DATE:	February 15, 2011	CO #:	31 (THIRTY-ONE)
TO:	DAG Construction 4924 Winton Road Cincinnati, Ohio 45232	PROJECT:	Gallatin County Lower Elementary Addition & Renovations Gallatin County, Kentucky BG 09-261 / RTA 0840

**THE CONTRACT IS CHANGED AS FOLLOWS:**

A  
FO211

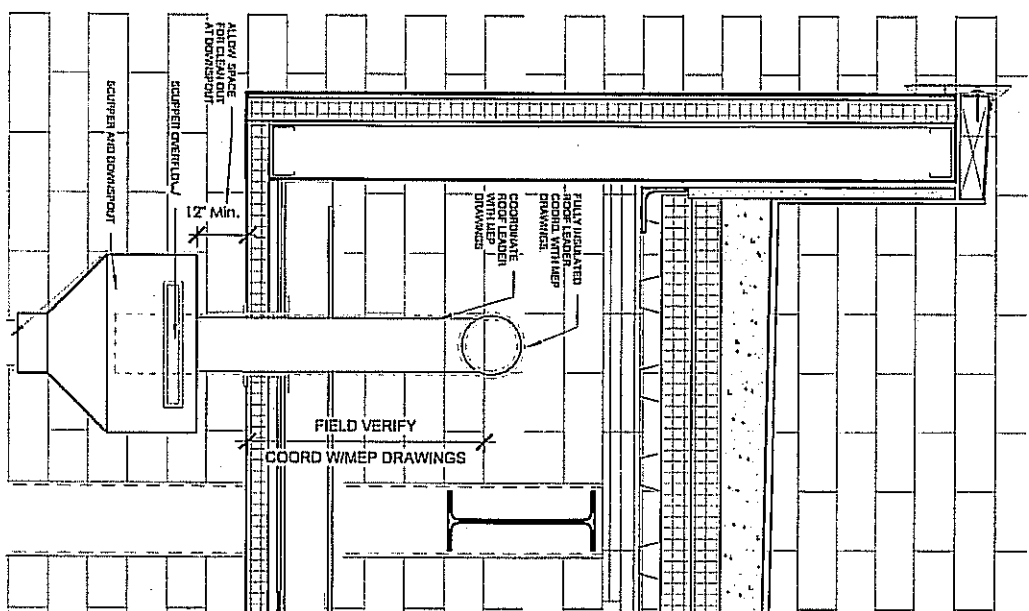
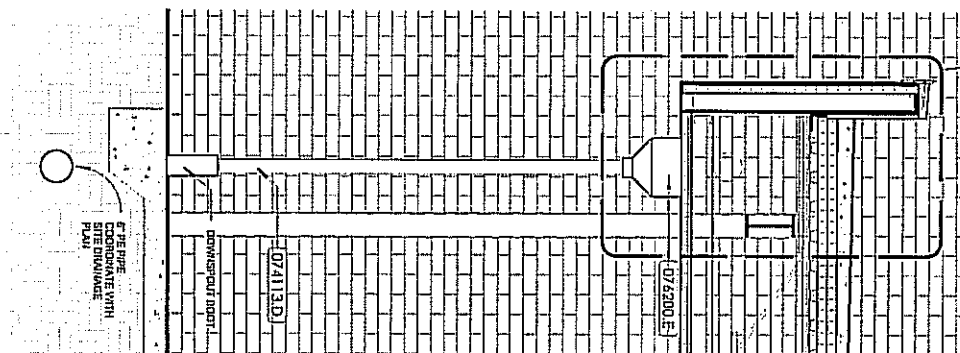
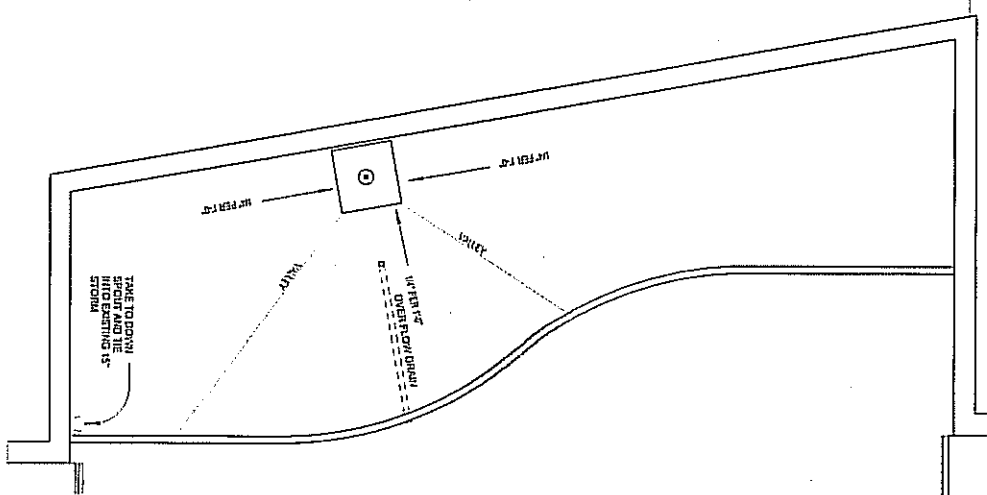
In response to RH 80, adjust the courtyard canopy roof drains and leaders as noted on attached drawings F021.1, F021.2, and F021.1XP3.2.1. Reduce the roof drains at the canopy from two drains originally illustrated on the A3 sheets to the one illustrated on F021.2. Adjust the piping to a scupper as illustrated on B and C/F021.2. Additional piping information is provided on XP3.2.1 and site storm adjustments concerning this item may be found on F021.1. Adjust the location of the emergency roof drain as noted on the F021.1 and XP3.2.1.

- 1 PROVIDE AND INSTALL DOWNCUT BOOT FOR CANOPY DRAIN CONNECTION.
- 2 PROVIDE AND INSTALL 6\"/>

AWING #  
FO21.1  
XP3.2.2

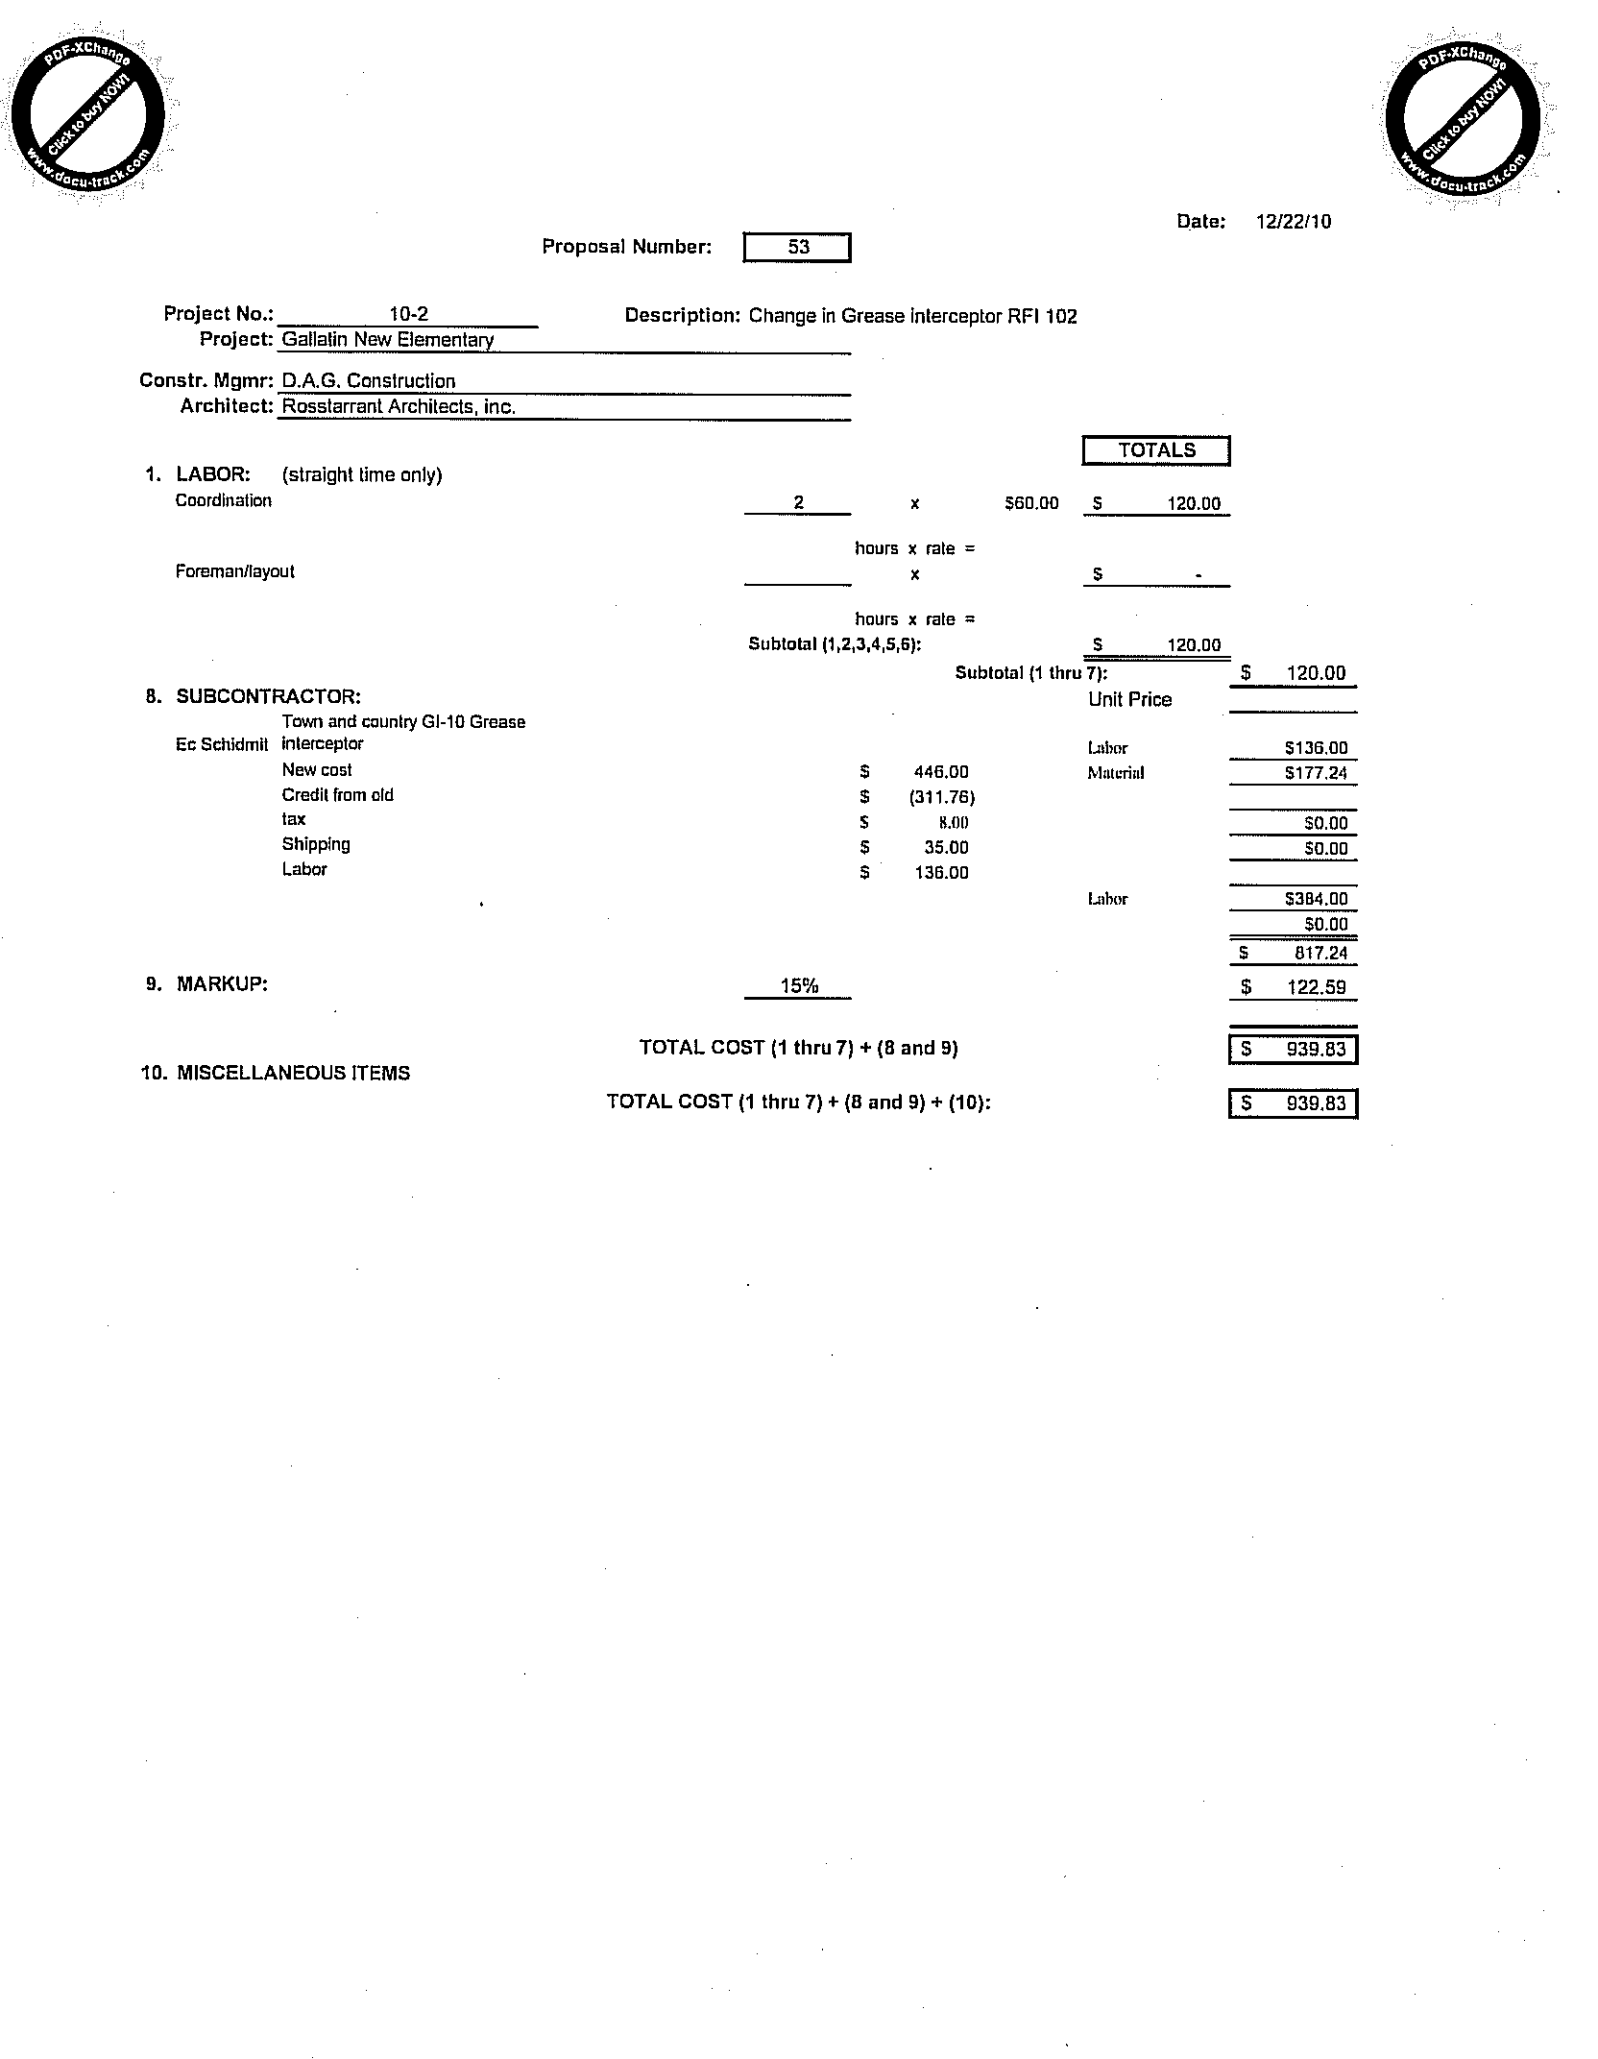
Additionally, adjust the storm drainage piping at Vestibule VA as illustrated on the attached XP3.2.2 drawing.
